City of Portland, Maine – Building or Use Permit Application 389 Congress Street, 04101, Tel: (207) 874-8703, FAX: 874-8716

REASON FOR PERMIT: extend dormer 10'

Revise plans for dormer

DATE: 9 MAR 98 ADDRESS: 34 Deering Ave
REASON FOR PERMIT: Revise dormer Plans
BUILDING OWNER: Morse
CONTRACTOR: Robert's Const. Co.
PERMIT APPLICANT: Robert Pavao
USE GROUP R-2 BOCA 1996 CONSTRUCTION TYPE 5B

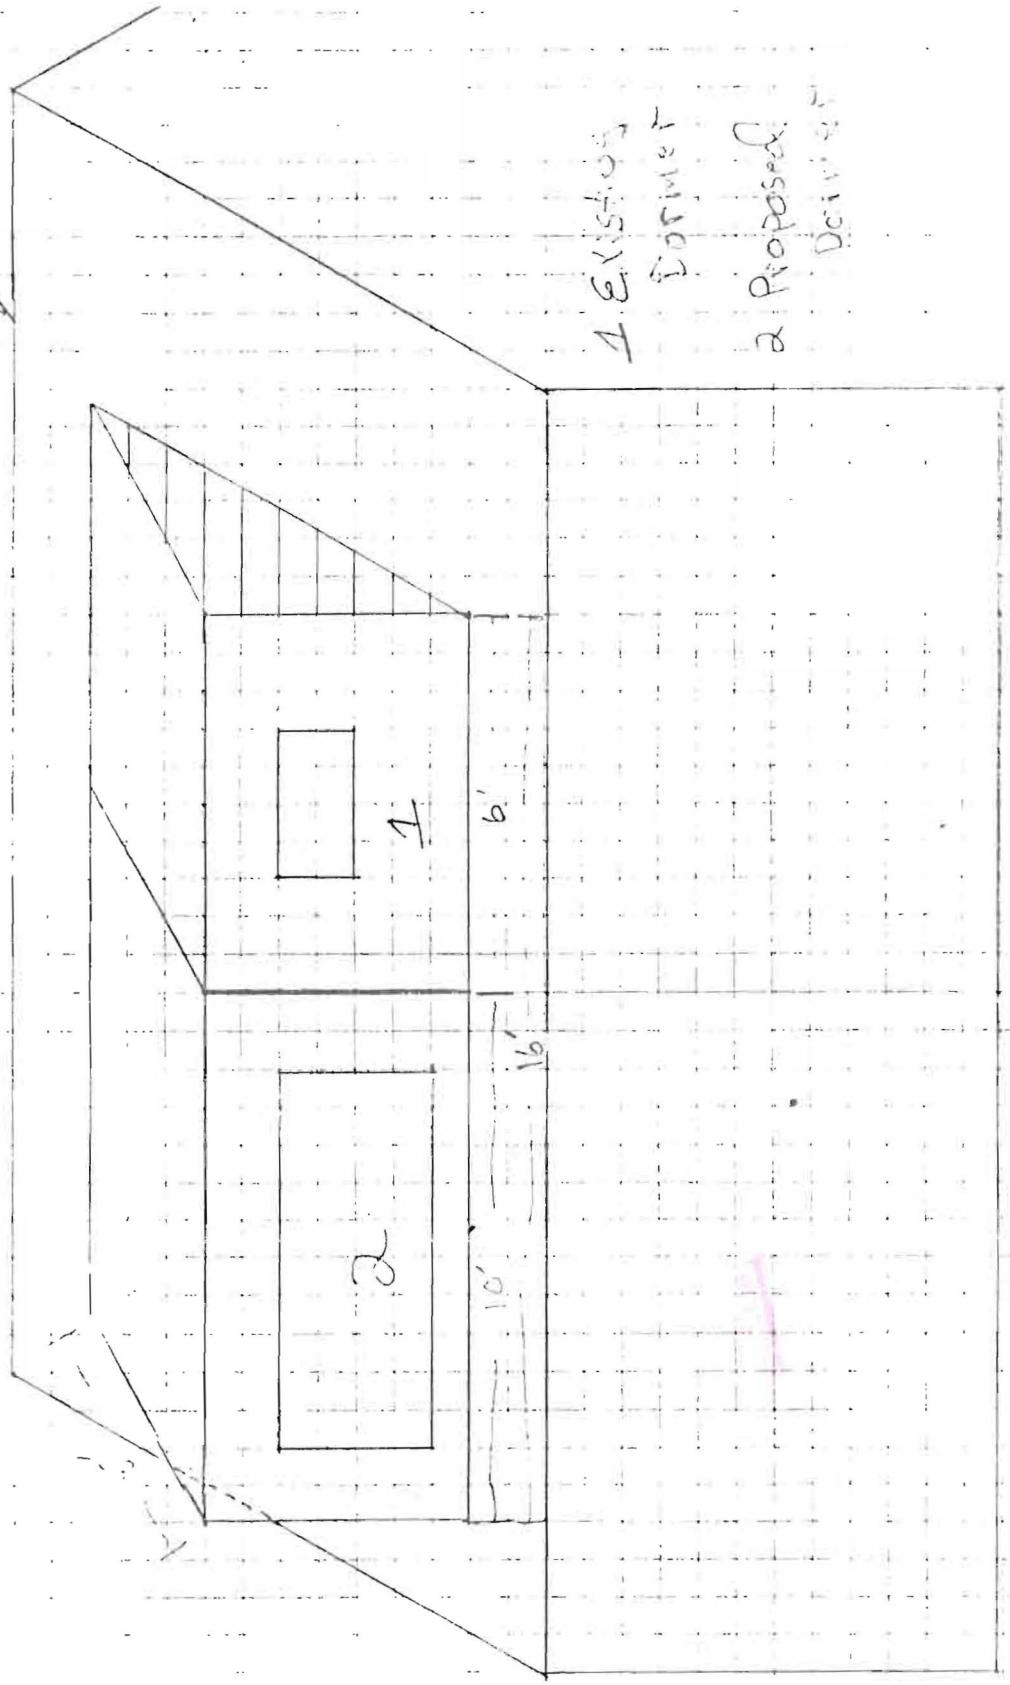
Note 2x8 rafters do not line up w/ 2x6 wall studs
 No Header over both window systems
 Roof is less than 4/12 pitch
 Rafter 8' span 2x8 e'oe (some dabled)

WINDOW DETAILS
 DORMER & GABLE REVISION

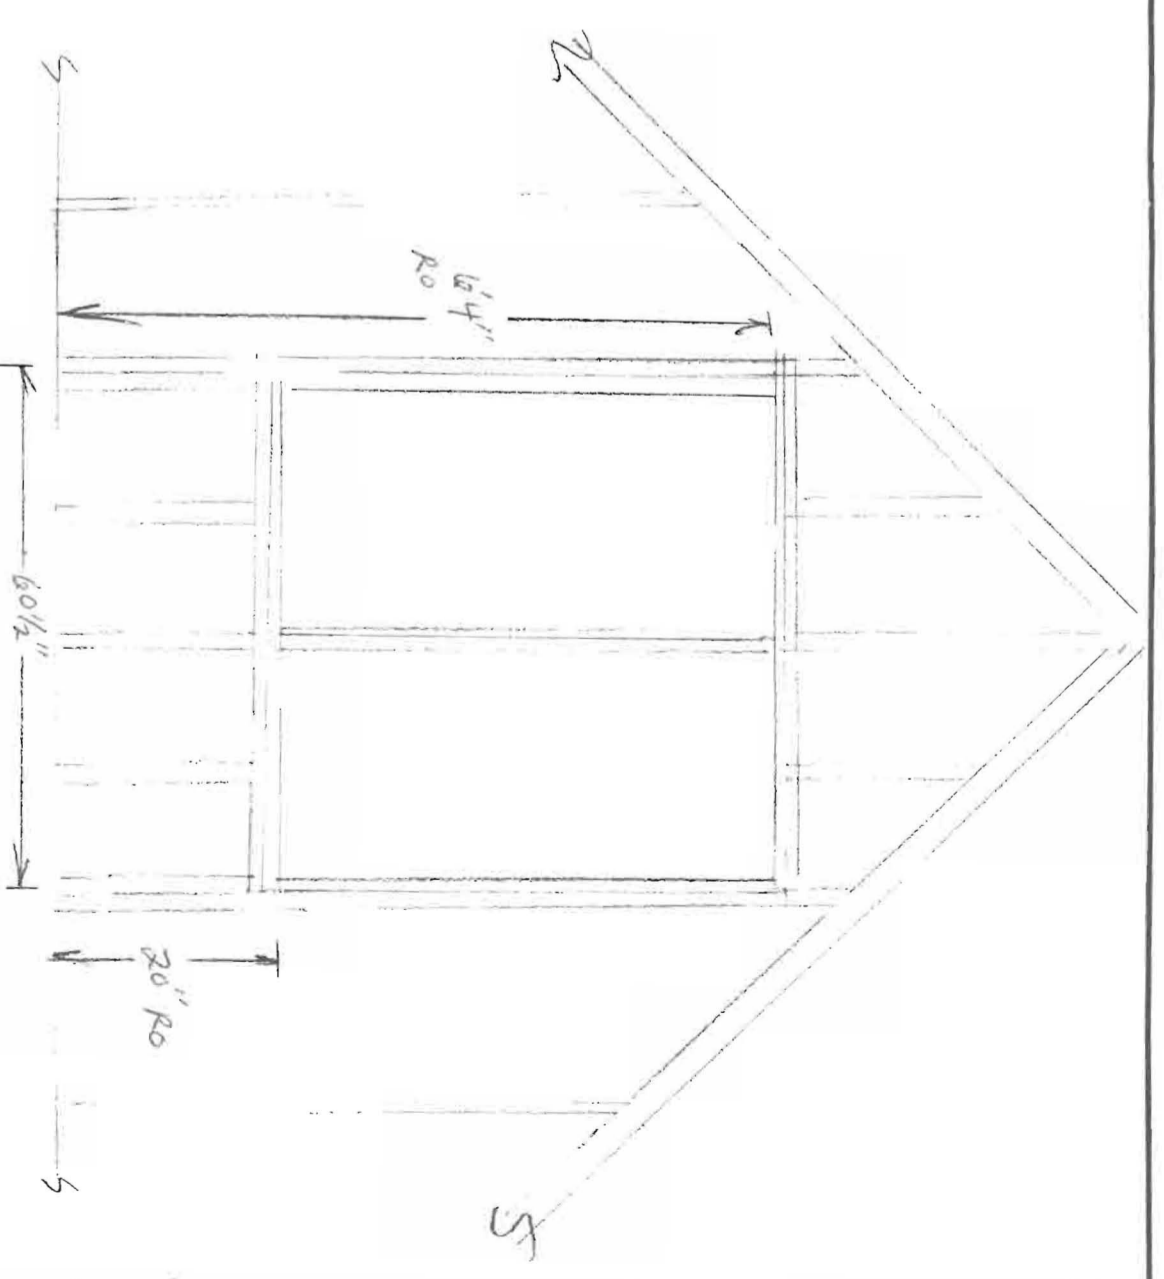
*Insp 2-20-95
Framing not to plans.*

EXISTING DORMER R.O. IS 5 1/2" H x 97" W WITHOUT HEADER

REDUCE RO TO 48" H x 97" W
 INSTALL: 6x8x100" HEADER
 DBL JACKS @ 3/4
 3- 2'3 1/2 x 3 3/4" PCLIA PROPOSED WINDOWS

EXISTING RO IS PROPOSED RO IS
 METHOD - CUT EXISTING STUDS IN STILL DBL NON-BEARING HEADER, JACKS AND CRIPPLES
 FINISH - INSTALL 2- 35x48 PCLIA PROPOSED WINDOWS

DORMER ROOF FORMING, BEARING WALLS AND
LOAD ESTIMATE

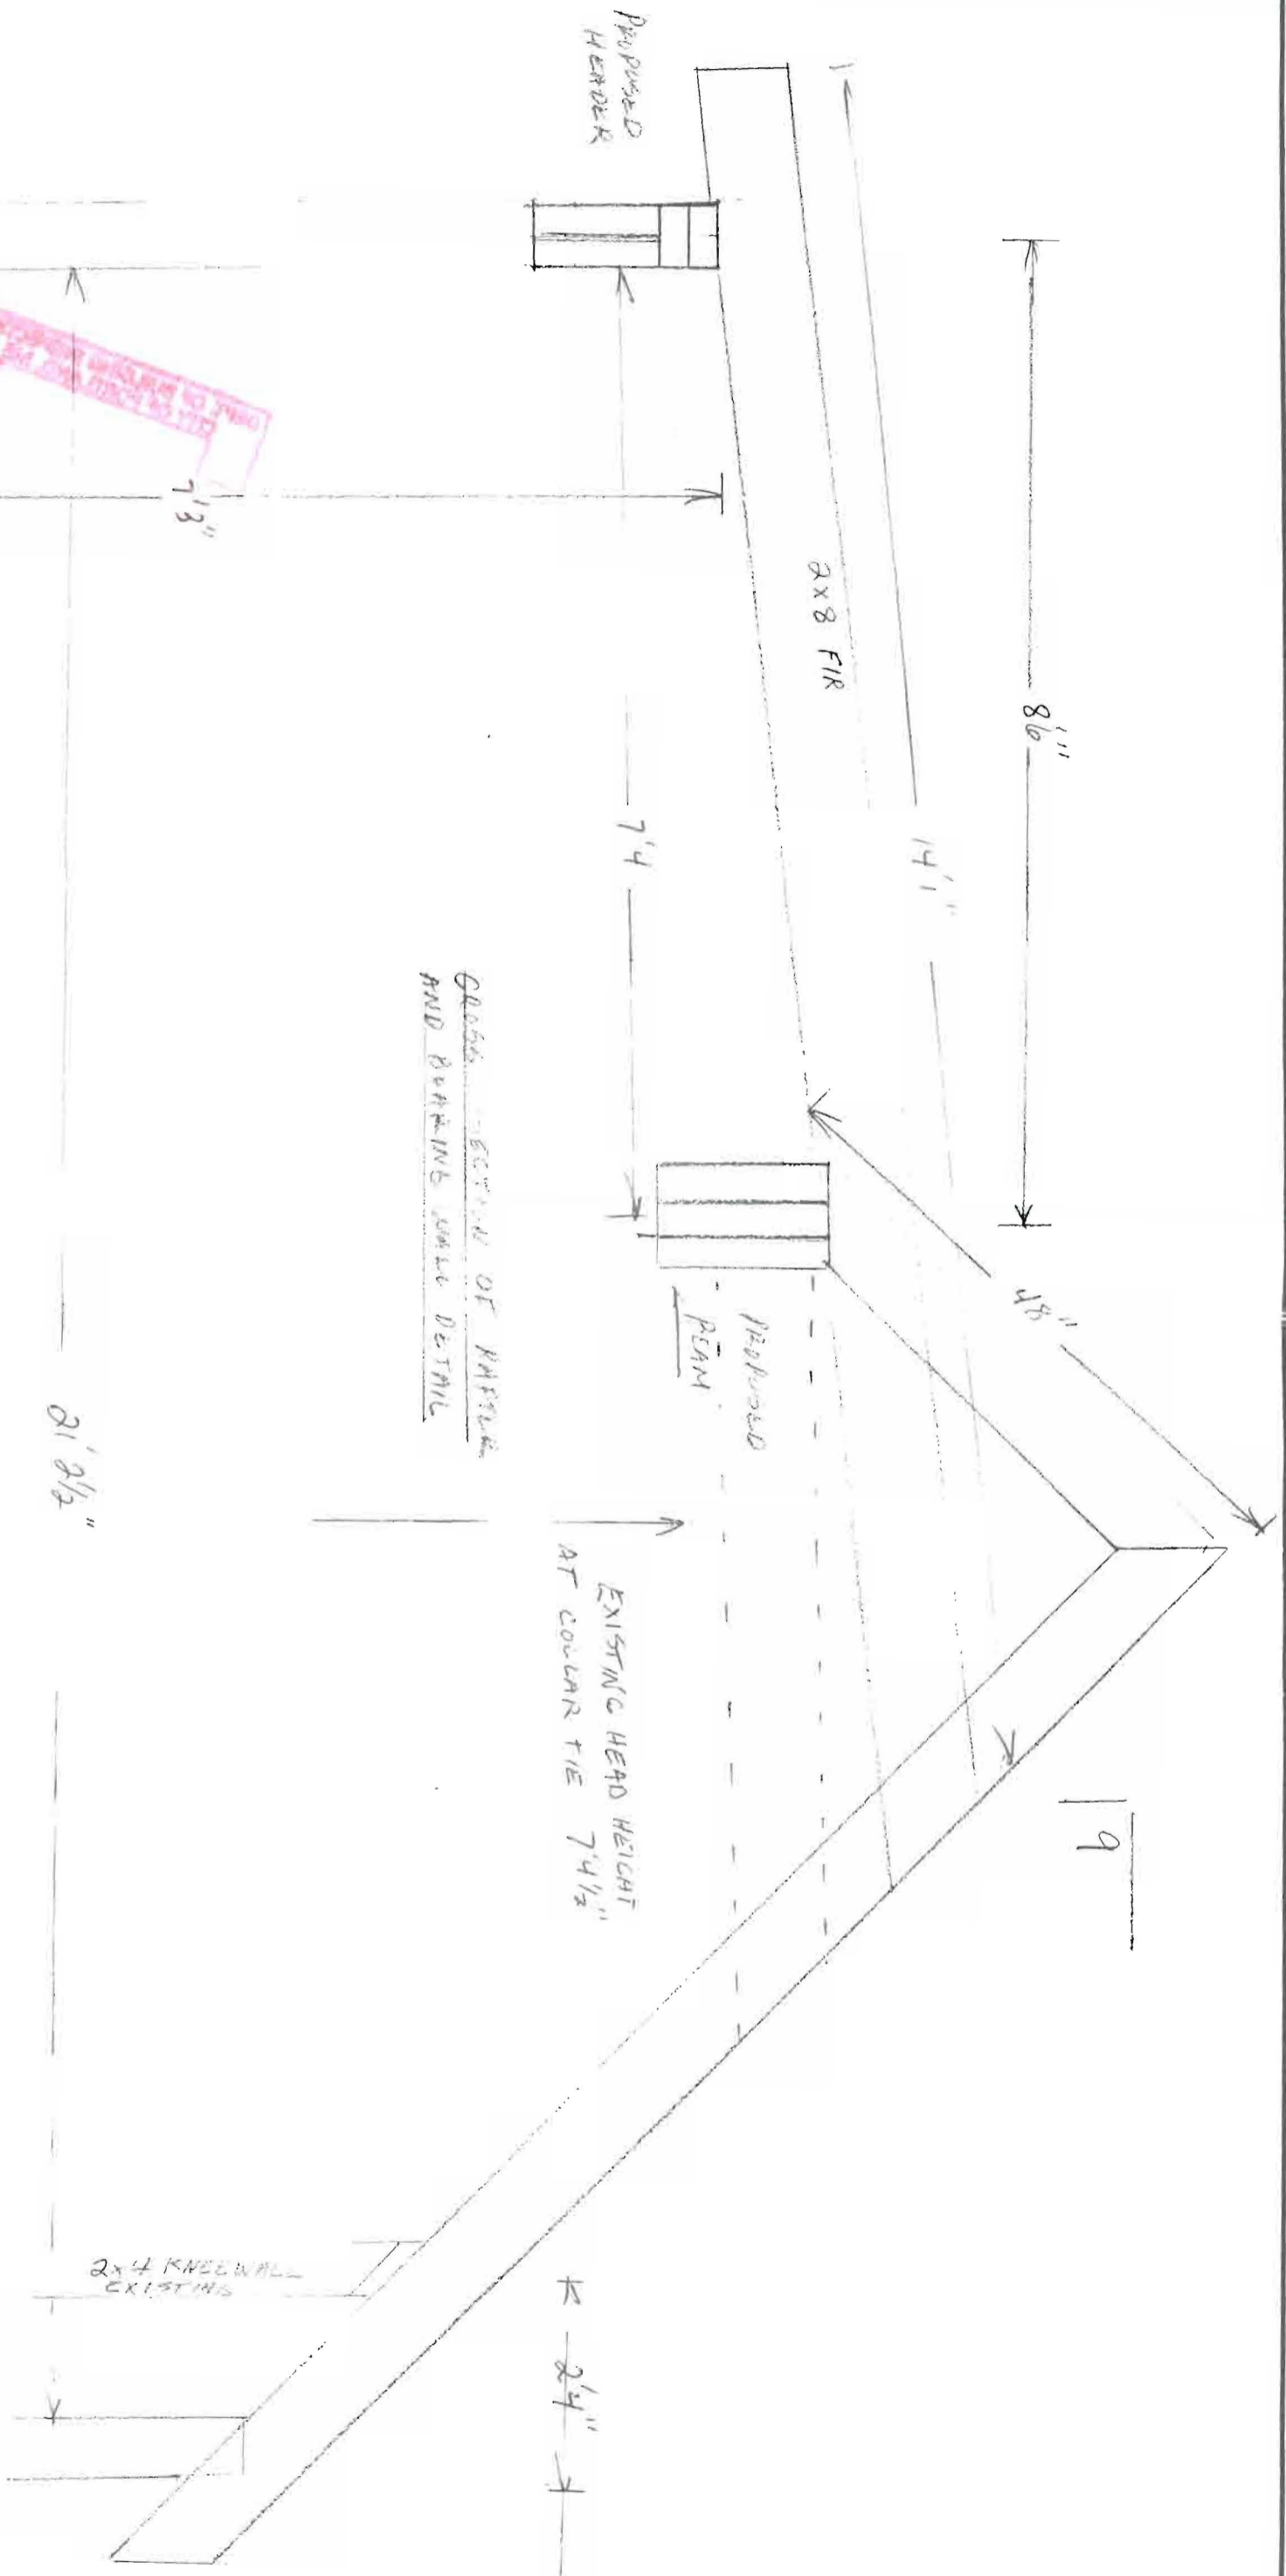
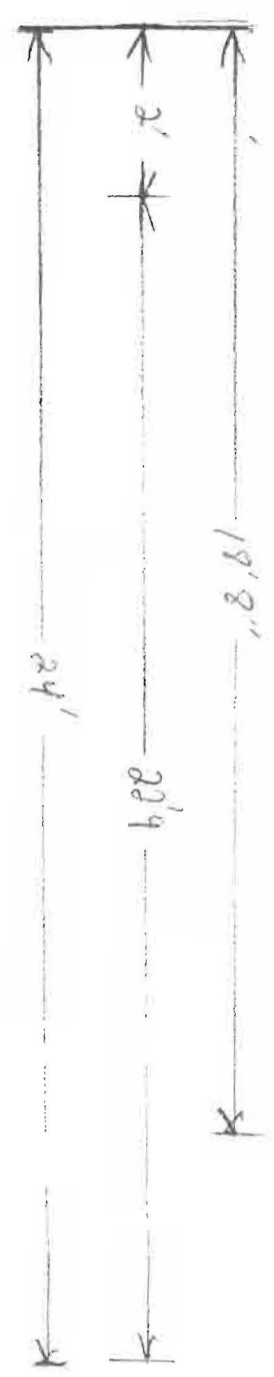
EXISTING RAFTER SPACING IS 28-32"
ORIGINAL DORMER CONSTRUCTION SYSTEMED
NEW RAFTERS TO EXISTING ONES
(NOT SHOWN)

PROPOSED RAFTER AT 24" IN ADDITION TO REF #1

3 - 1 3/4 X 11 7/8 LVL
24' L SPAN
